APPLICATION NO	PA/2022/1884
APPLICANT	Mr Sam Waddington
DEVELOPMENT	Application for a non-material amendment to PA/2020/602 namely to amend the siting of proposed building
LOCATION	22 Bigby High Road, Brigg, DN20 9HD
PARISH	Brigg
WARD	Brigg and Wolds
CASE OFFICER	Alan Redmond
SUMMARY RECOMMENDATION	Approve
REASONS FOR REFERENCE TO COMMITTEE	Manager discretion

RECOMMENDATION Approve a non-material amendment.

Block Plan 1:500

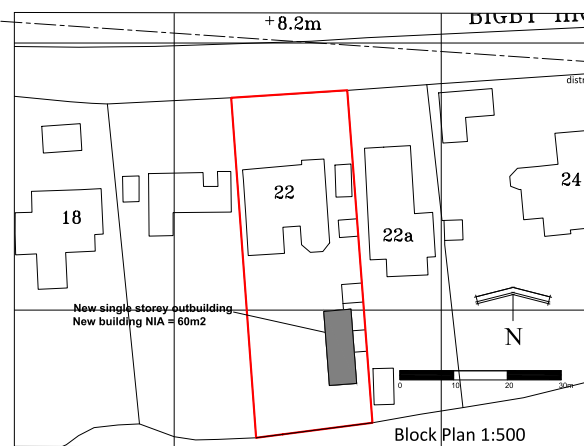
In the context of this development, the only alteration to the annex, over that approved under PA/2020/602, is the siting of the building. The proposal remains as previously approved in terms of scale and design. The proposal re-positions the annex approximately 1.83m further south than approved.

The submitted drawings show the eastern side elevation of the annex to be approximately 2.2m from the shared boundary with number 24, consistent with the original approval. Concern has been raised that the annex is built approximately 1.8 metres from the shared boundary. However, the council's enforcement officer has visited the site and confirmed that the measurements as shown on the submitted drawings are correct (within accepted tolerances). Notwithstanding this, the case officer has visited the site and viewed the annex building in its built position, which has enabled them to make an accurate assessment of the building and its impacts. It is considered that there is an acceptable separation distance to neighbouring properties given the single-storey scale of the building and its authorised use as ancillary residential accommodation.

The siting of the annex further south by 1.83m results in the annex building being sited further from the dwelling at 22a than originally approved under PA/2020/602. Overall, this is considered to be an improved relationship that would not result in any undue additional impacts in terms of amenity over and above the original approval and is in accordance with

Rev B As built SO of building altered to 11.83m from existing house. Apr 22
 Rev A Sampling chamber to septic tank added, drain field shown. Soakaway size shown Sept 20
